ADDENDUM NO. TWO (2)
TOWN OF BRASELTON, GEORGIA
2026 GROUNDWATER EXPANSION AND DISTRIBUTION STORAGE
ISSUED JANUARY 23, 2026

RE: 2026 GROUNDWATER EXPANSION AND DISTRIBUTION STORAGE
EMI PROJECT No. 18-021

The purpose of this Addendum is to provide the omitted storage tank drawings, existing contours for treatment site, the pre-bid meeting attendance, and add Precon Corporation as a pre-approved concrete storage tank manufacturer. The following items of the Contract Documents are modified as part of this Addendum:

M10
SHEET

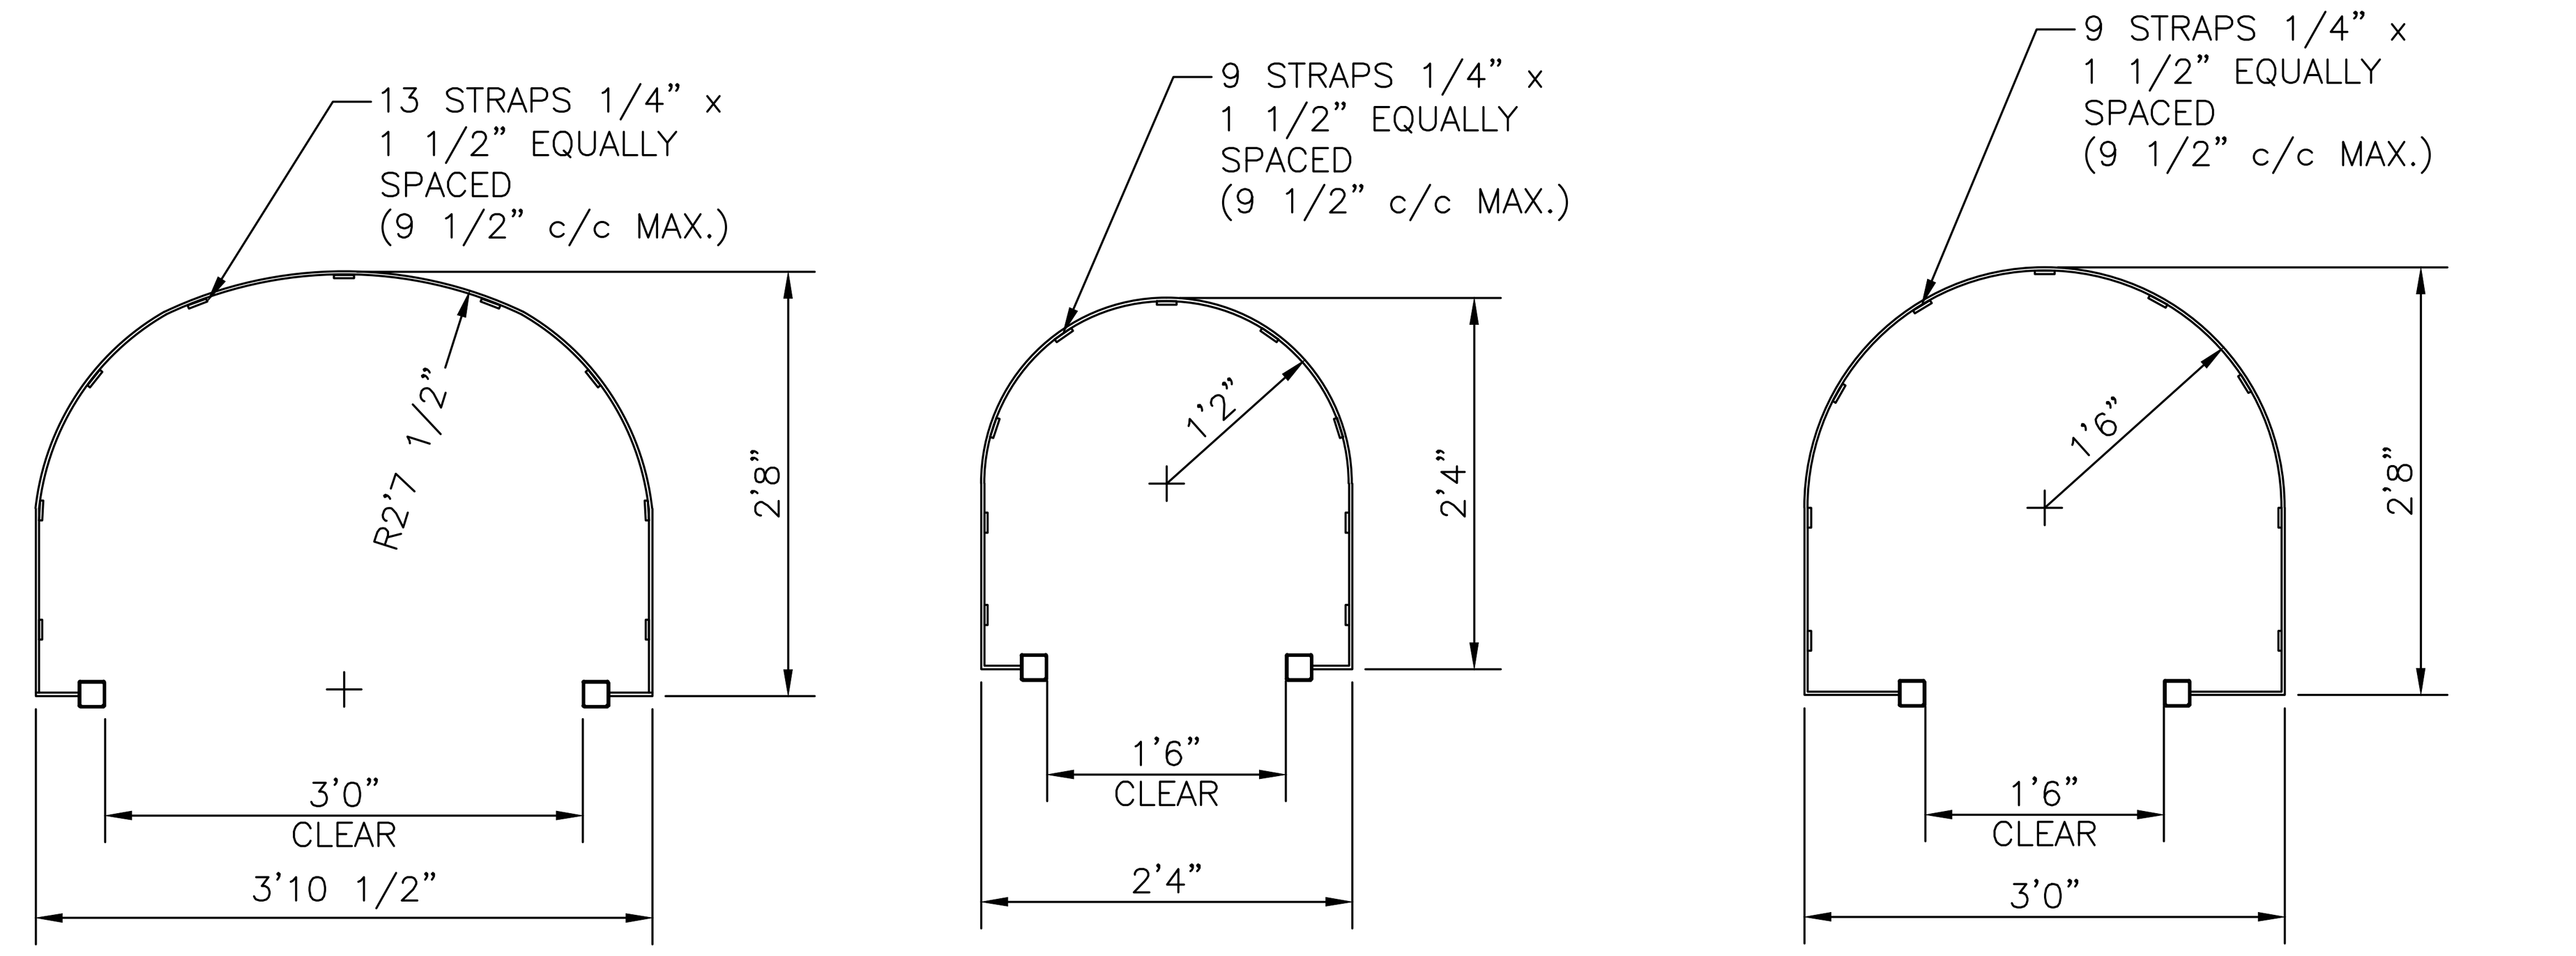
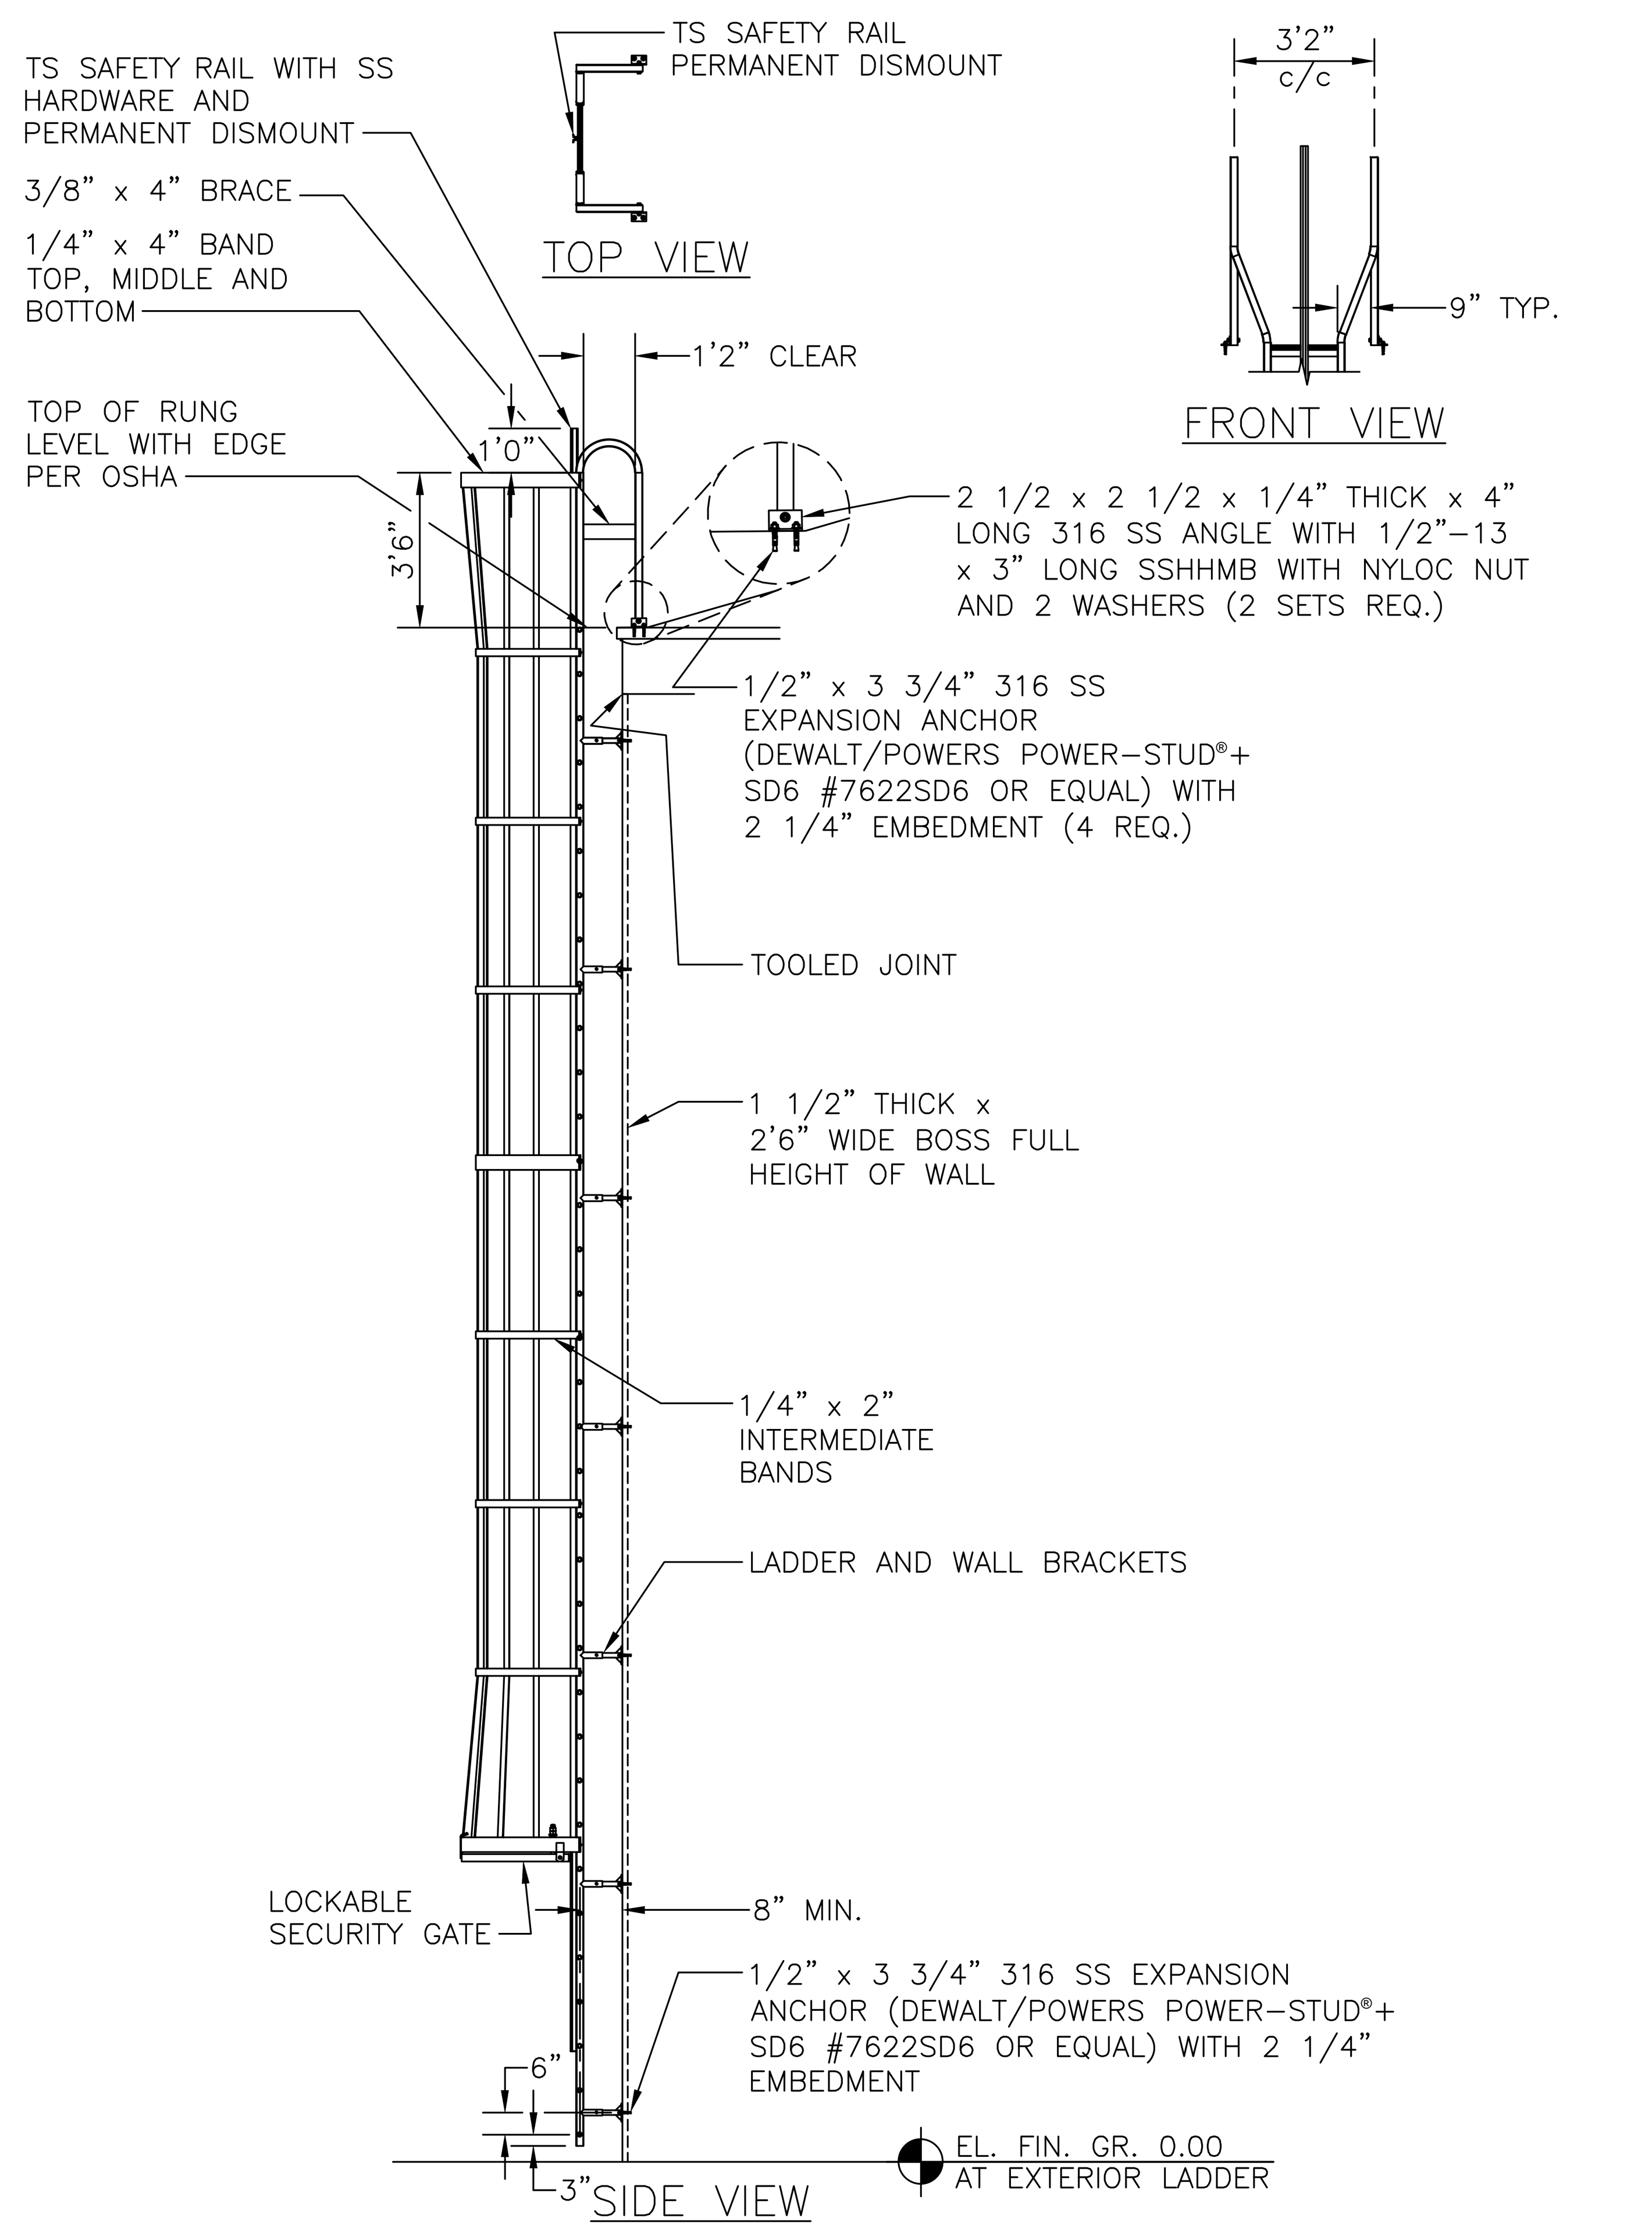
1. The contract documents appear to be missing plan sheets M7-M10 for the new tank listed in the sheet index. Can you please provide the missing drawings?

- <u>*Plan sheets M7-M10 have been provided to show plans for the concrete storage tank. See attached plan sheets.*</u>

EMI Response: Sheets M7-M10 were omitted in error. Please see the original sheets attached to this addendum.
